Contact No. 272Image: Second seco

Changes to UB & UB2 Pushbuttons; LB, UB & UB2 Iluminated Pushbuttons; LB, UB & UB2 Indicators

Change Notice

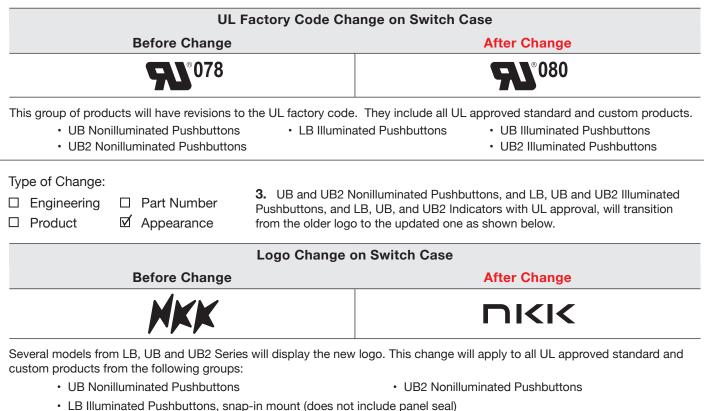
2. UB and UB2 Nonilluminated Pushbuttons, and LB, UB and UB2 Illuminated Pushbuttons, all with UL approval, will have a change on the switch case for all standard and custom devices. Previously, the UL symbol appeared on the case with factory code 078. After the change, the code 080 will appear next to the UL symbol. The table below illustrates the modification.
